Access Compliance Report

Public Rights-of-Way

(Curb Ramps)

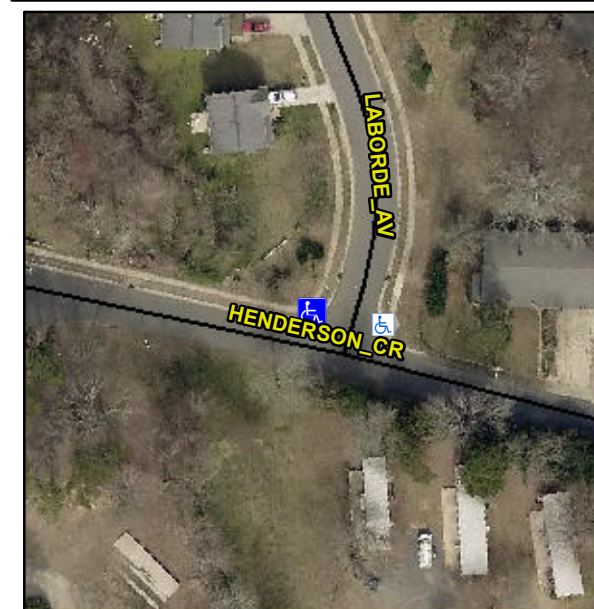
Intersection ID: 45437	Main Street: HENDERSON_CR	Cross Street: LABORDE_AV	Location: NW
ADA ID: DEF57081B192	Ramp Type: Perp	Initial Pass/Fail: Fail	Overall Compliance: No
Codes/Mitigation Info/Possible Solution			Severity Score: 60
			Field Measurements/Component Compliance

Not Found, R304.5.1, R304.2.2

Compliance	Description	Data	Compliance	Description	Data
N/A	Ramp Length (in)	49.5	No	Ramp Slope (%)	15.7
No	Ramp Width (in)	30.0	Yes	Ramp XSlope (%)	1.5
N/A	Flare Type LT	N/A	N/A	Flare Type RT	N/A
N/A	Flare Slope LT (%)	N/A	N/A	Flare Slope RT (%)	N/A
N/A	Flare Traversable LT?	N/A	N/A	Flare Traversable RT?	N/A
N/A	Landing Length (in)	N/A	N/A	DWS Provided?	N/A
N/A	Landing Width (in)	N/A	N/A	DWS Contrast?	N/A
N/A	Landing Slope (%)	N/A	N/A	DWS Length (in)	N/A
N/A	Landing X Slope (%)	N/A	N/A	DWS Full Width?	N/A
N/A	Landing Curb? (Y/N)	N/A	N/A	DWS Offset (in)	N/A
N/A	Shared Landing?	N/A			
N/A	Gutter Ponding?	N/A	N/A	Gutter Slope (%)	N/A
N/A	Gutter Lip Ht (in)	N/A	N/A	Gutter X Slope (%)	N/A
N/A	Painted X Walk1?	No	N/A	Painted X Walk2?	N/A
	X Walk 1 Direction	To SE		X Walk 2 Direction	N/A
N/A	X Walk 1 Width (in)	N/A	N/A	X Walk 2 Width (in)	N/A
	X Walk 1 Slope (%)	4.3		X Walk 2 Slope (%)	N/A
	X Walk 1 X Slope (%)	0.1		X Walk 2 X Slope (%)	N/A

Remove & Replace Entire Ramp.
